Solicitation No.: B240003BAG

Solicitation Name: Sunniland / Nine Mile Run Drainage Improvement Project

Subject: Addendum Number 1

WEIR DESIGN - WEIR-2						SUNNILAND / NINE MILE RUN DRAINAGE IMPROVEMENT PROJECT		LEE COUNTY, FLORIDA	
DATE	PROJECT	DRAWING	DESIGN	DRAWN	CHECKED	SCALE	SHEET		
5/14/2019	8234	_WEIR-1	KWK	SDJ	KWK	AS NOTED	17B

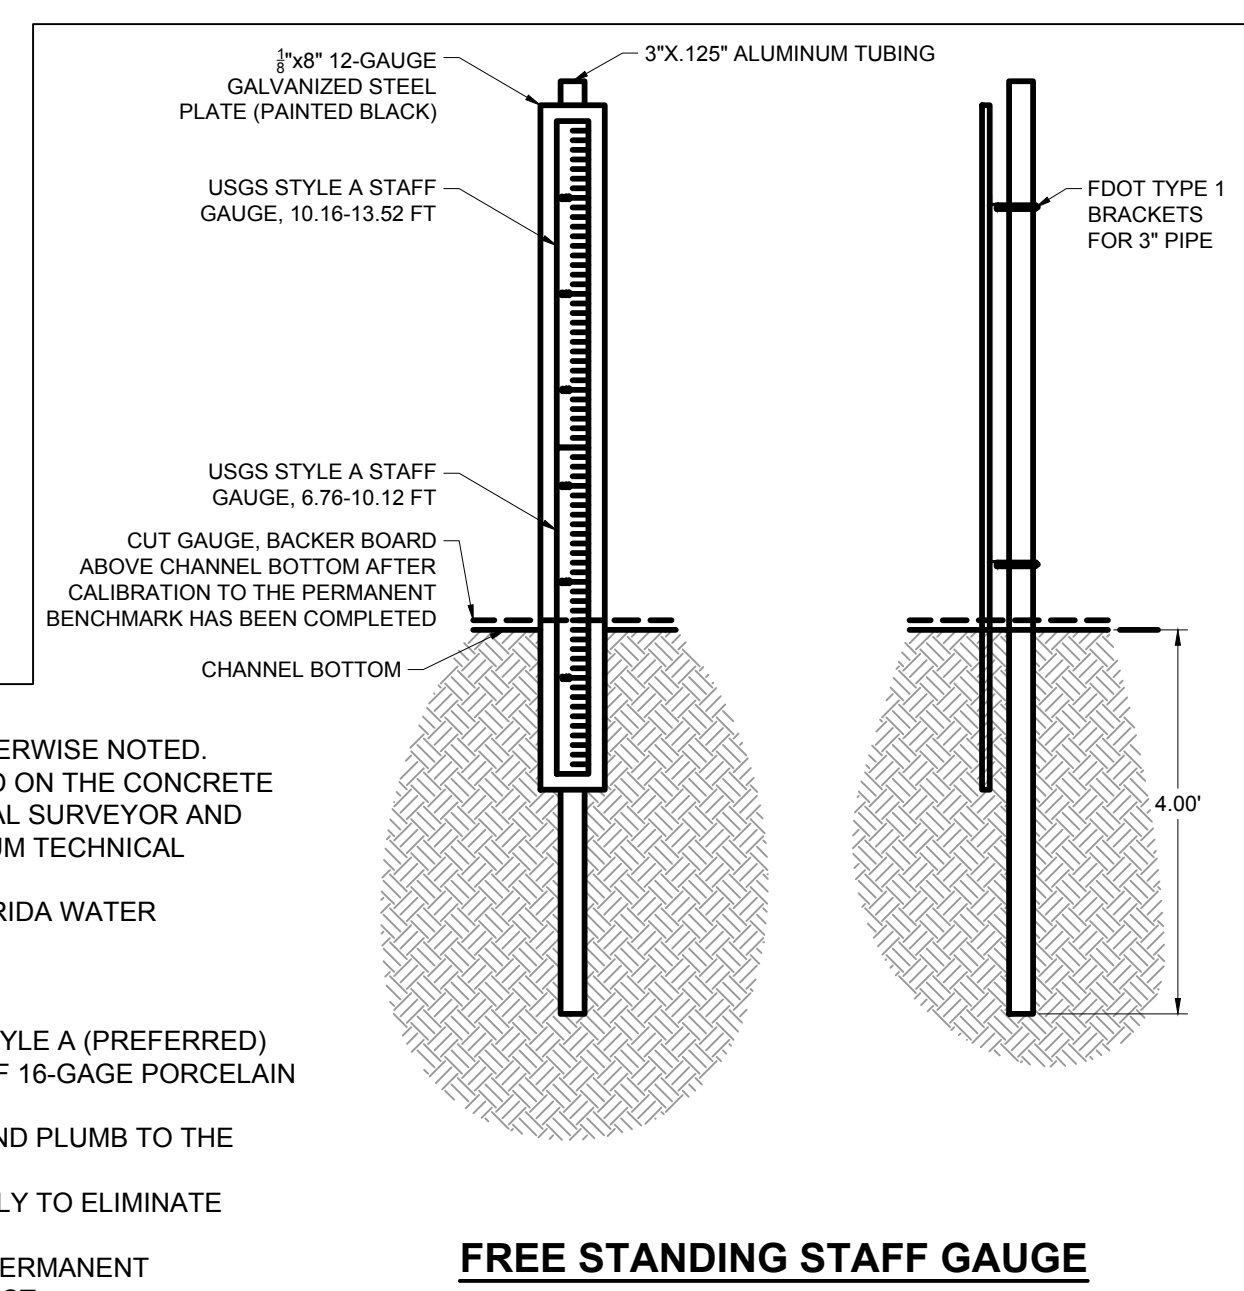
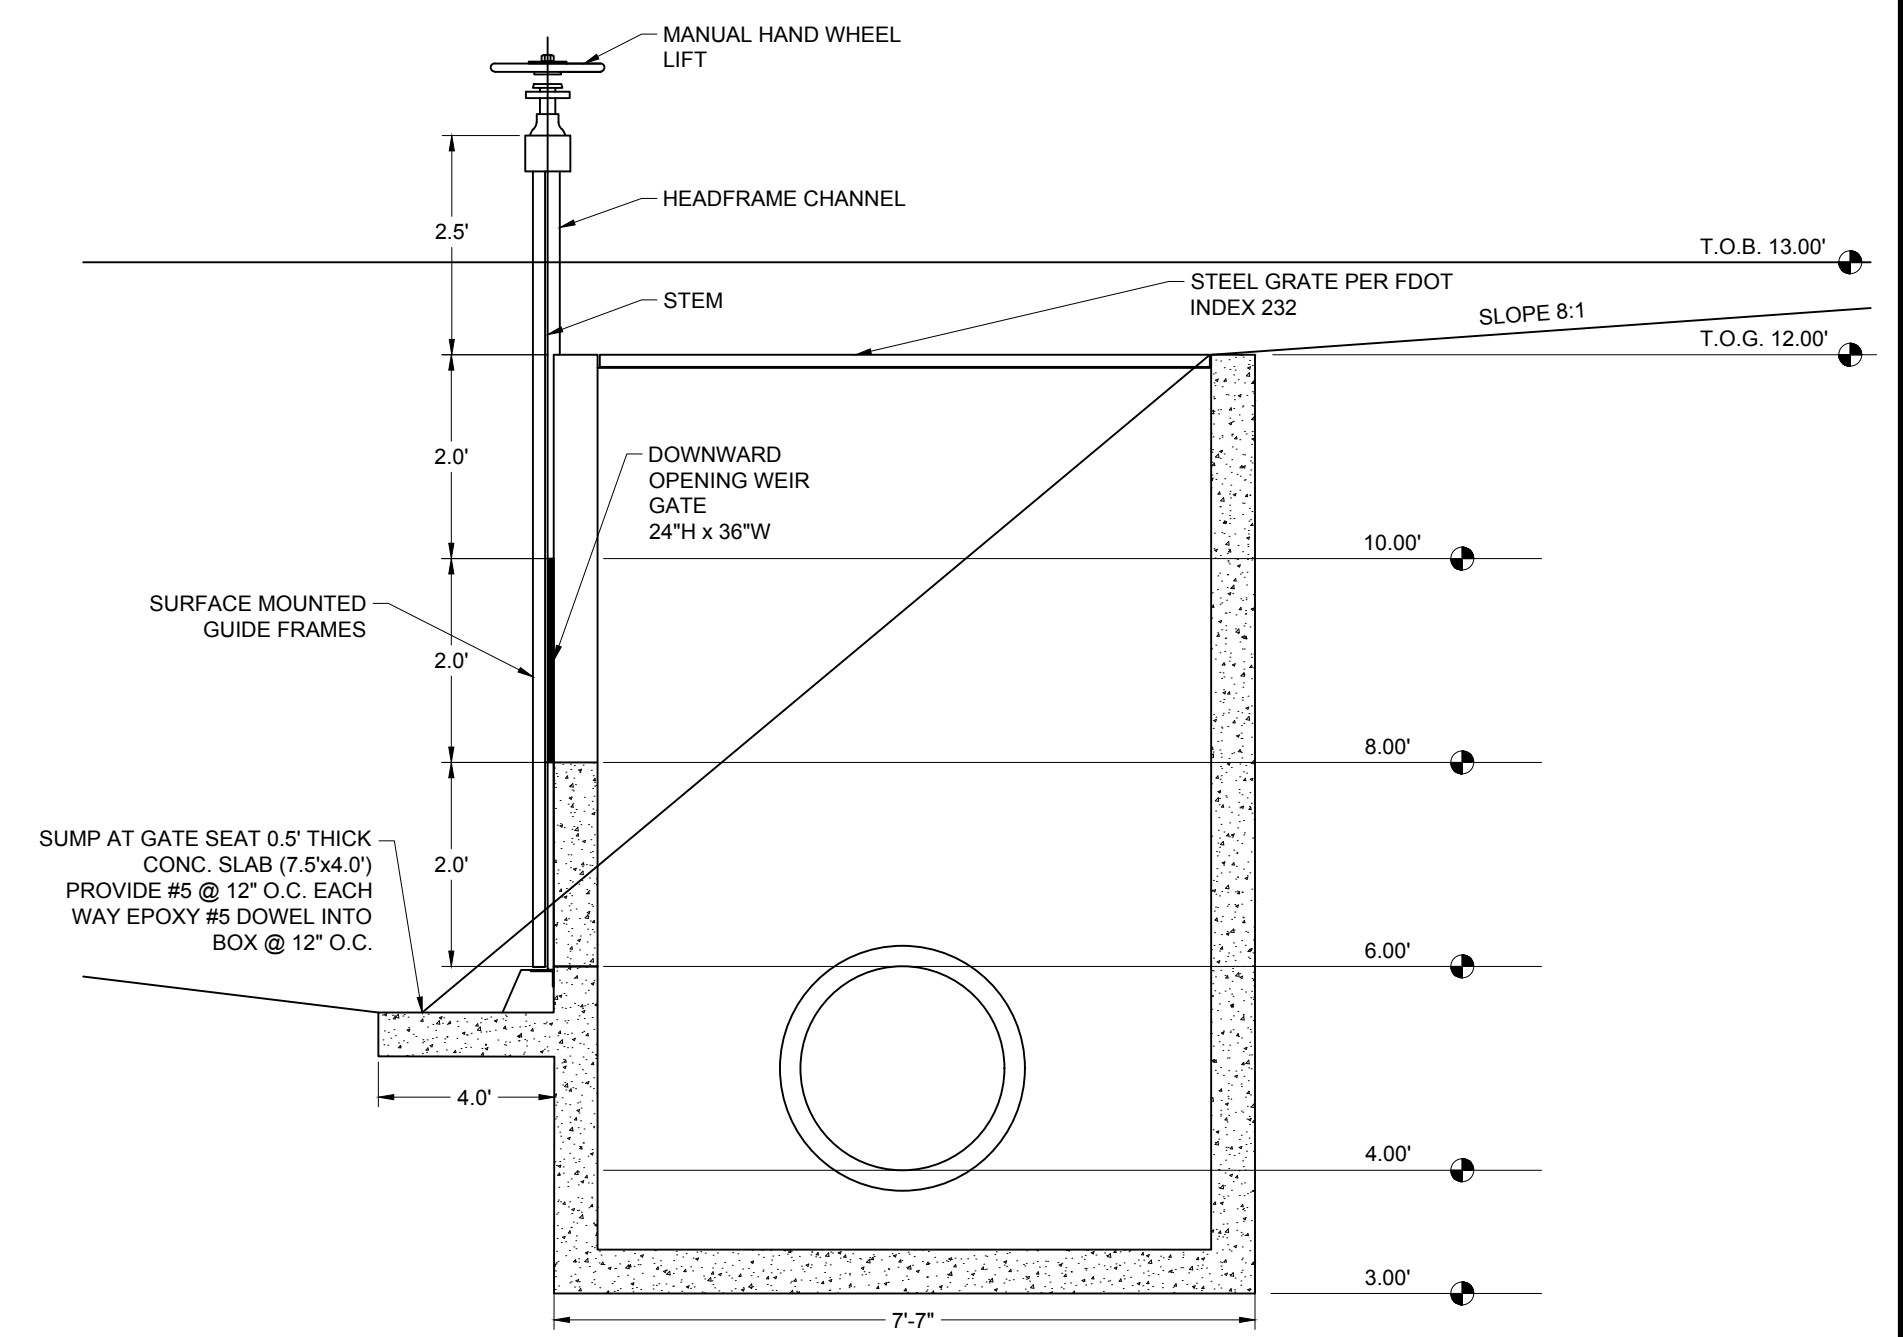
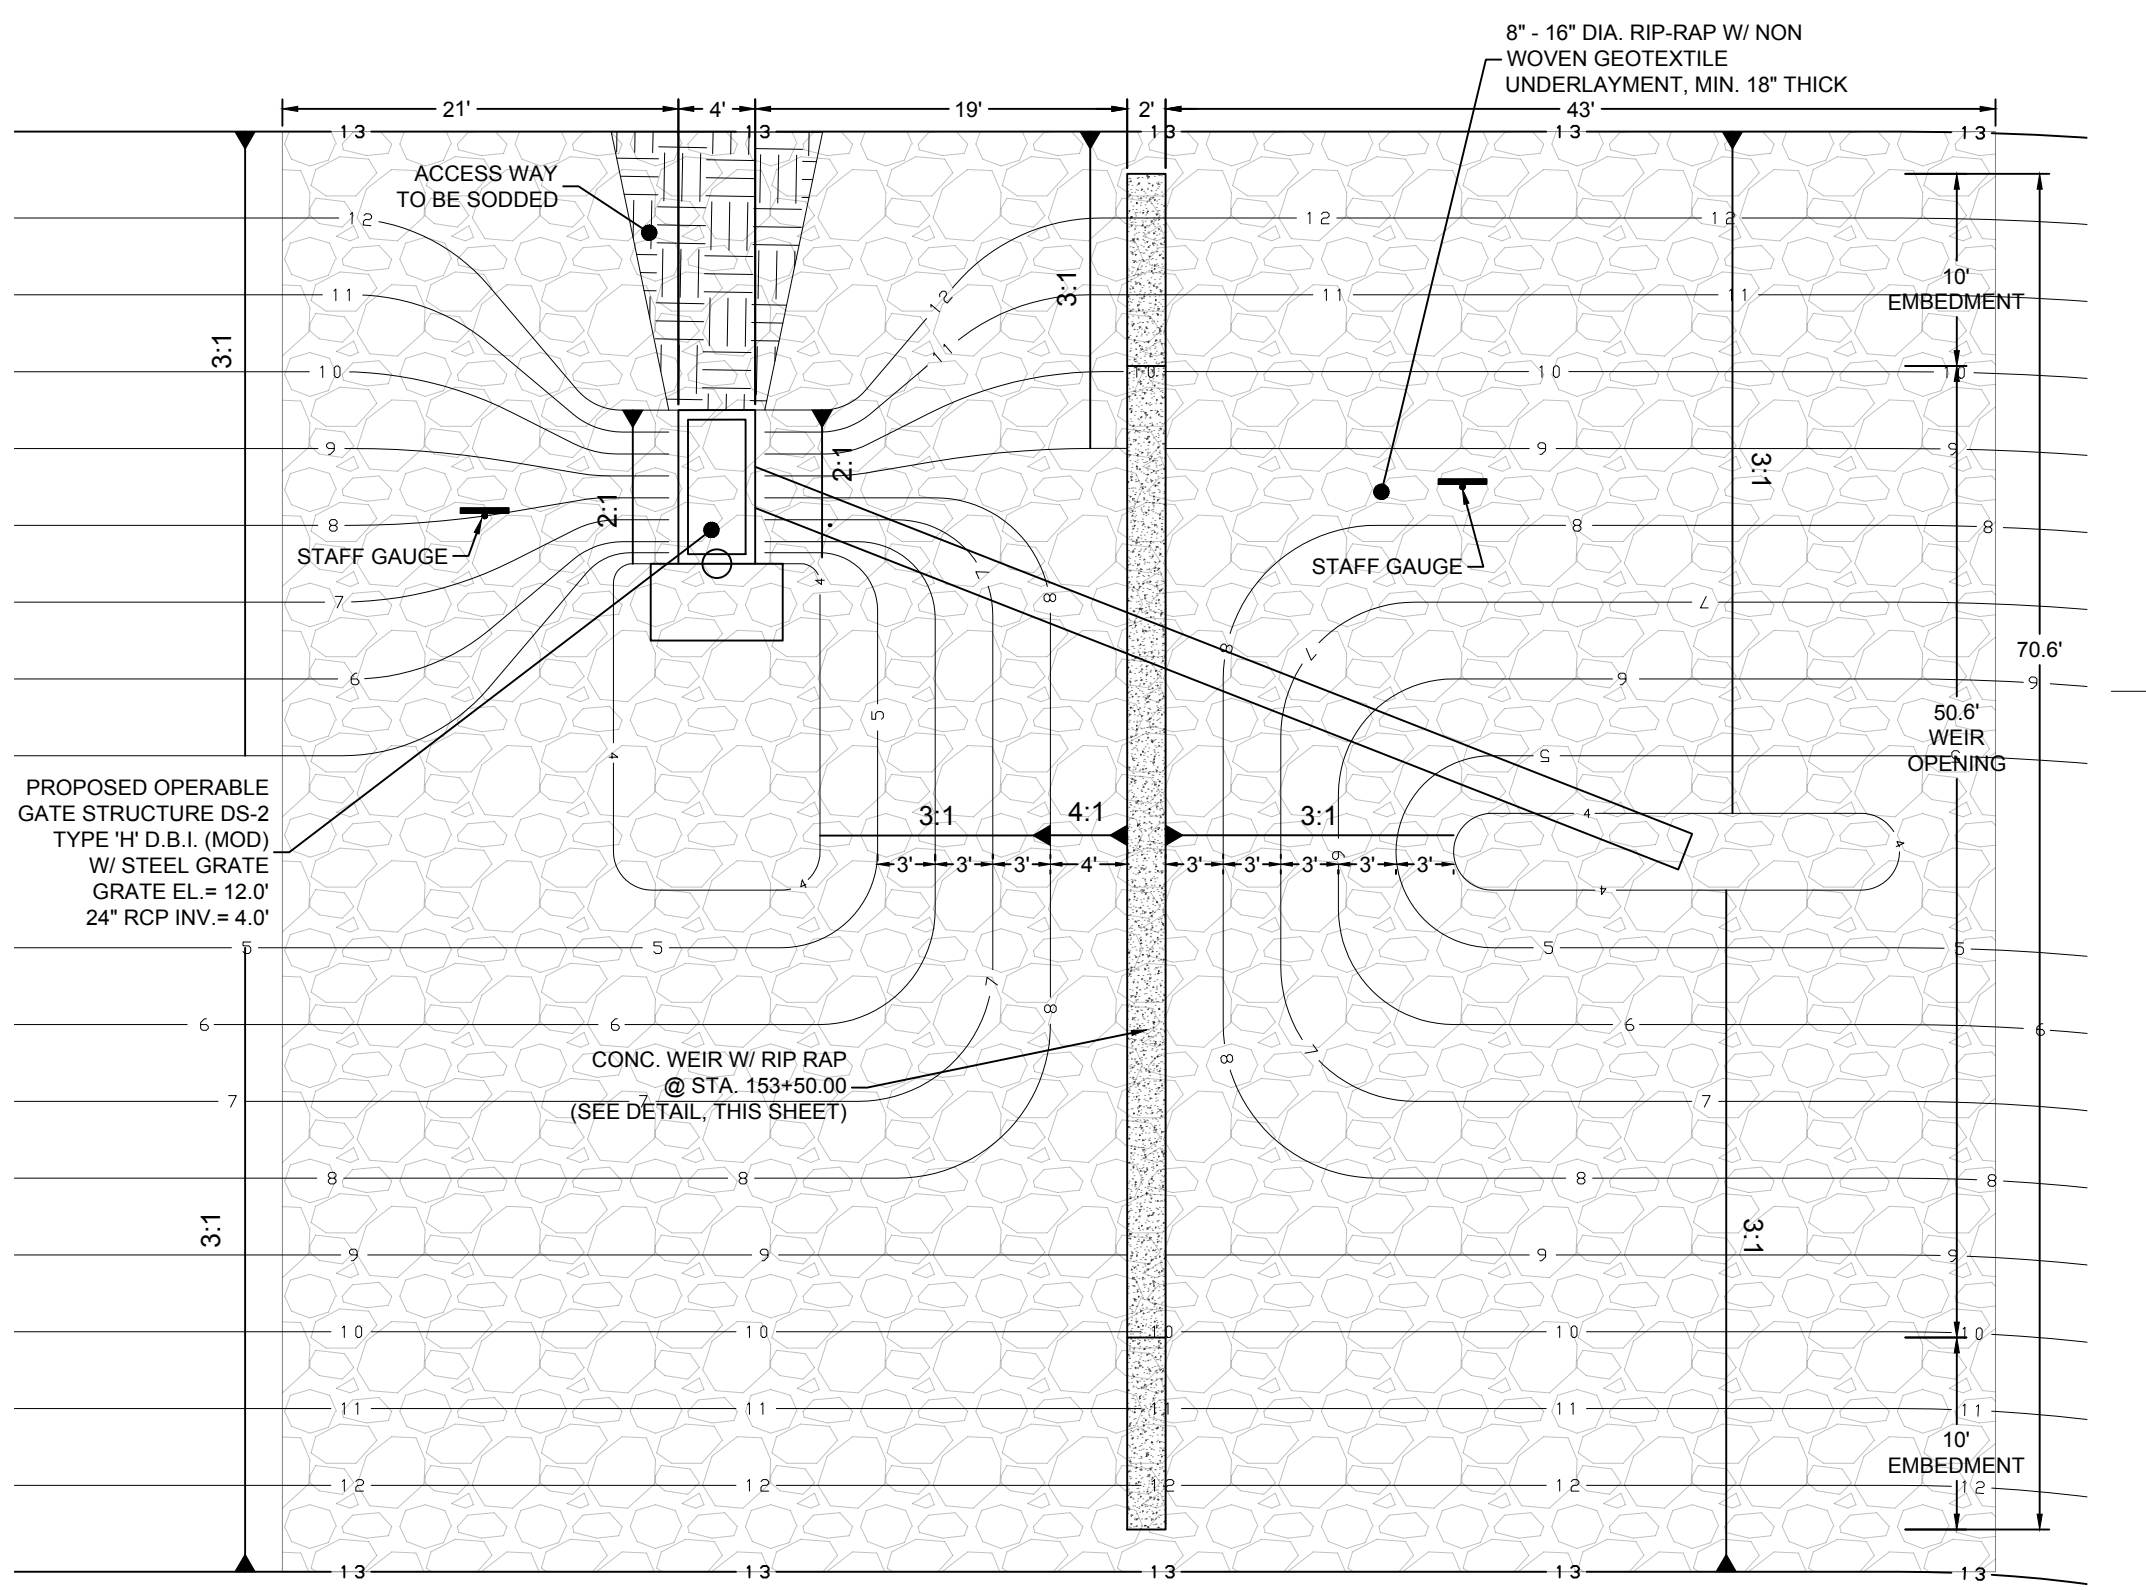
Answer	10-ft down from the top of bank
10.	Regarding weir's # 1 & 2, please clarify the following. Sheet 17 shows a FDOT index 252 that depicts a typical weir section. However, sheets 17A (weir # 1) & 17B (weir # 2) shows a typical weir section which is a concrete 2' x 2' area. Question, which section is correct?

15.	Can the engineer provide some additional clarification for the two through weirs? Sheet 17 depicts a typical section of a type of through weir, sheets 17A and 17B depict a 24" x 24" weir detail, however the X-section A-A shown on both sheets depicts a detail that does not reflect either of the individual weir details. Please advise.

Answer	Sheets 17A and 17B are correct. Disregard FDOT Index 252.
11.	If the work is to be majority if not all self-performed does the contractor still need to run an add for the DBE requirement?

Answer	Sheets 17A and 17B are correct. Ignore section on sheet 17.
16.	Drawing Sheet 5 depicts (3) thirty-inch RCP mitered end sections. However, the bid form does not list any. Can a new 30" MES bid item be included on a revised bid form?
